PCN# : P685AAB
Issue Date : Aug. 31, 2016

Information Only Notification

TO263 Carrier tape

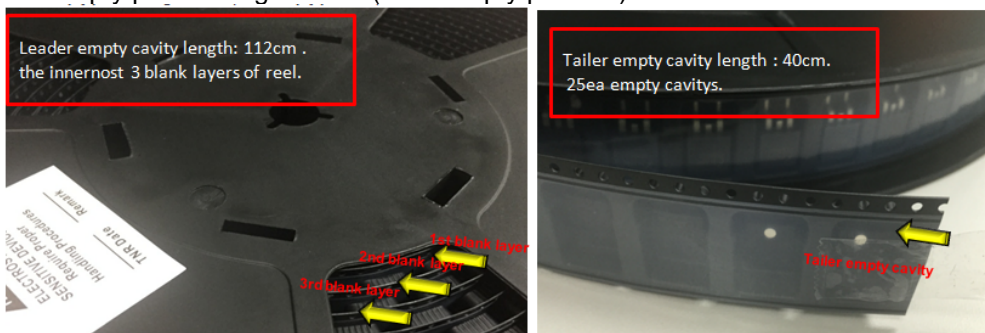
Lead empty length: 72cm(45ea empty pockets, the innermost 2 blank layers of reel).

Tail empty pocket length: 80cm(50ea empty pockets).

Lead empty length: 112cm(70ea empty pockets, the innermost 3 blank layers of reel).

Tail empty pocket length: 40cm(25ea empty pockets).

The change is to mitigate lead deformation during product transportation.
